Updating the Sweeper Headers

Engine	Serial Number Range
HP525 EFI	0M956572 and below
HP600 SCi, HP662 SCi, HP700 SCi	0M962885 and below

Header Replacement

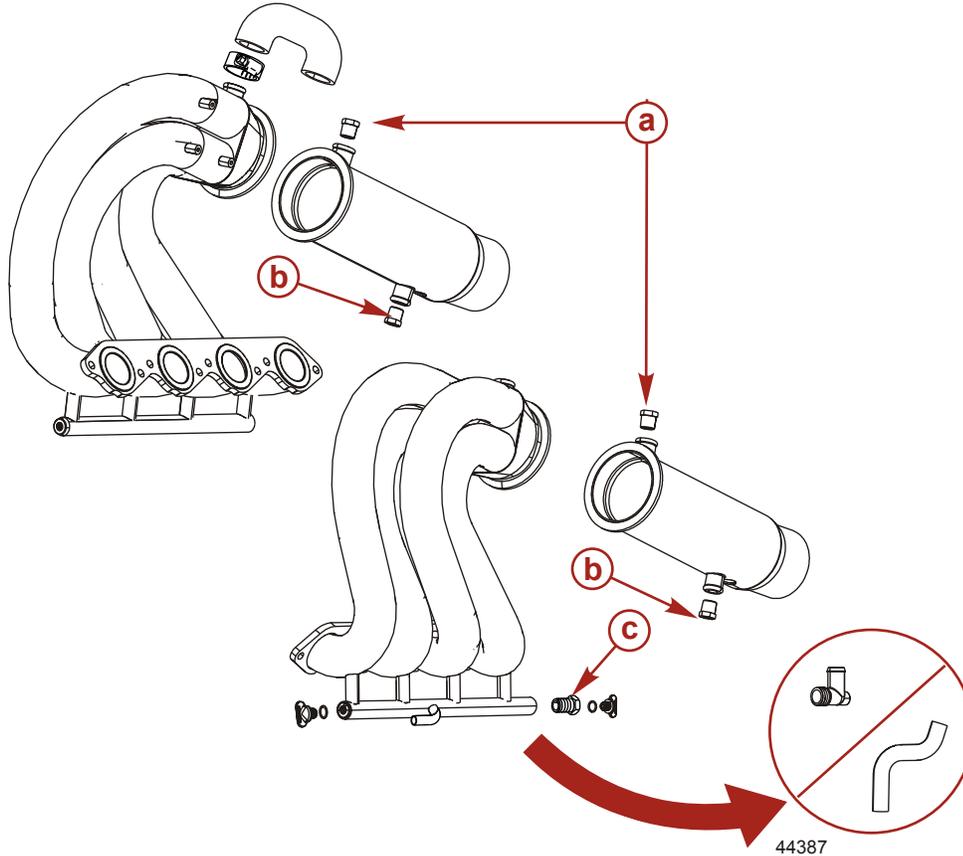
The older style headers with the header by-pass hoses are no longer available. Replacement headers and tailpipes have a different configuration requiring some new fittings to complete the update.

1. Remove the hose adapter (elbow) fitting and the by-pass hose from the header that is not being replaced.
2. Install the bushing/reducer.
3. Remove the plug from the hose adapter and screw it into the bushing reducer.

IMPORTANT: Both tailpipes must have a 0.406 in. (13/32 in.) restrictor installed in the top fitting.

4. Install a 0.406 in. restrictor in the top fitting of the starboard tailpipe.
5. Install a brass plug in each of the lower tailpipe fittings
